SYM	REVISIONS	APPROVED	DATE
			A	AS ISSUED	-----	-----
58			B	C61 was 47uF/10V	B3-03128	0.GROSS 23.06.98
			C	CHANGED Q7, Q11		03.03.00

ITEM	QTY.	PART/MATERIAL-DESCRIPTION	MAT'L-PART NO.	MAT'L-DWG. NO.	MAT'L-SPEC.
Stefan Olejniczak DRAWN BY	28.09.93	DATE	SCHEMATIC Xmitter-Board /users/dfrank/egs/M1310A/xmitter_d TITLE		
Stefan Olejniczak ENGINEER/CHECKER	28.09.93	DATE			
Peter Volk RELEASE TO PROD.	18.02.94	DATE			
SUPERSEDES DWG.			SCALE	SHEET 1 OF 1	Agilent Technologies M1310-66501 PART NUMBER D-M1310-96501-1

POWER SUPPLY

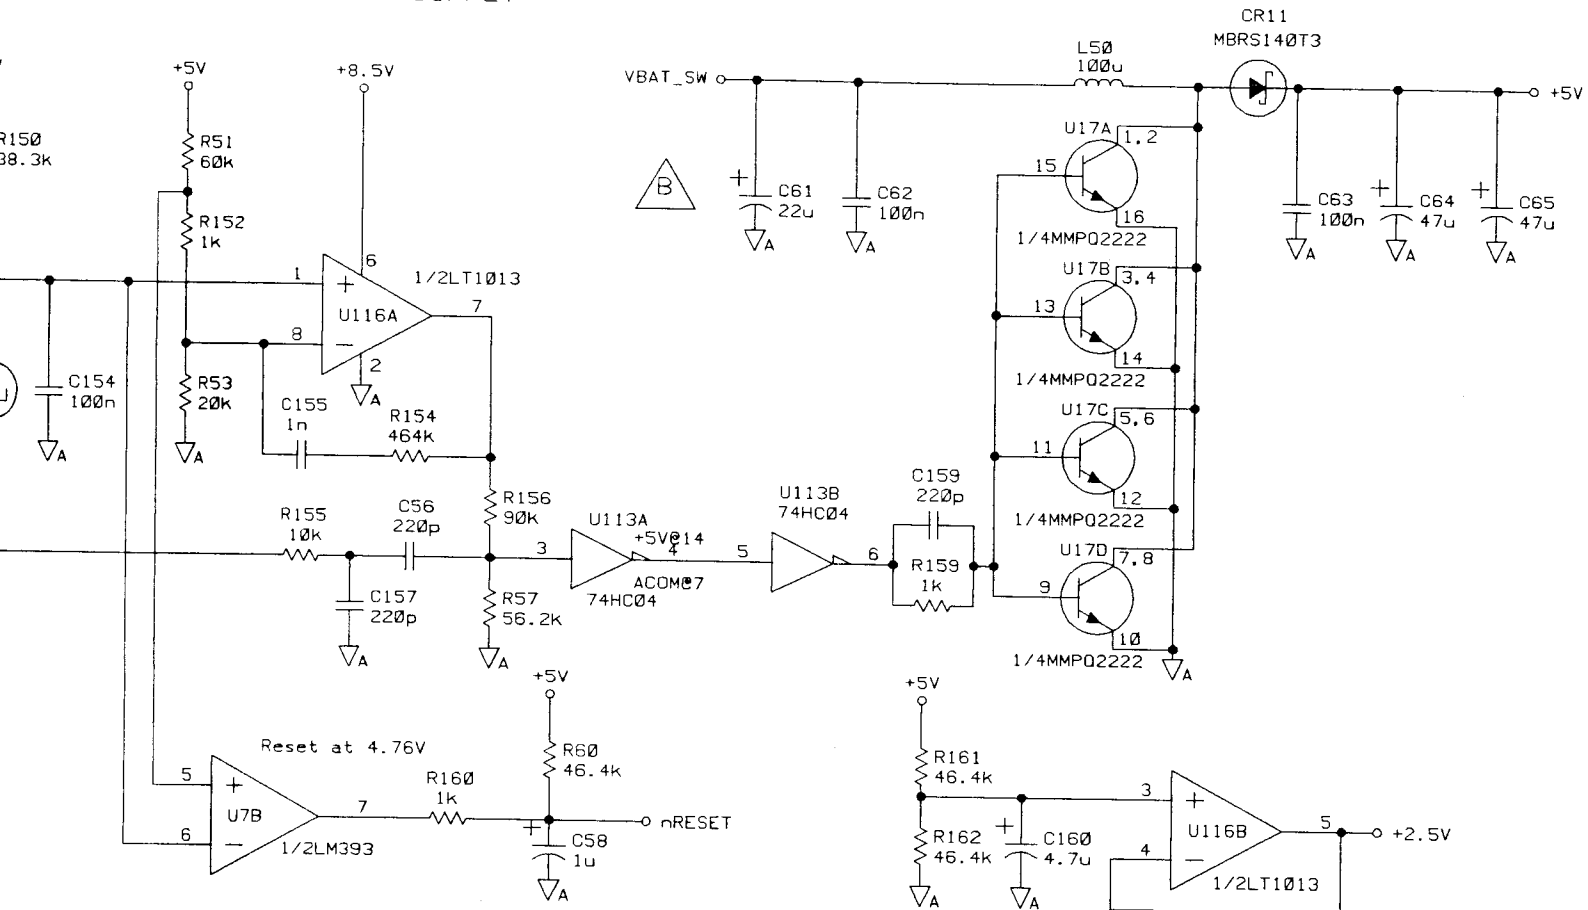
Q7 REPLACED BY NDS332P P/N 1855-1051

Q11 REPLACED BY NDS331N P/N 1855-1054

Q8, Q9, Q10, Q12, Q13, Q14, SET TO - N O L O A D -

REASON : REDUCTION OF RDS ON TO ELIMINATE FINALTEST PROBLEMS
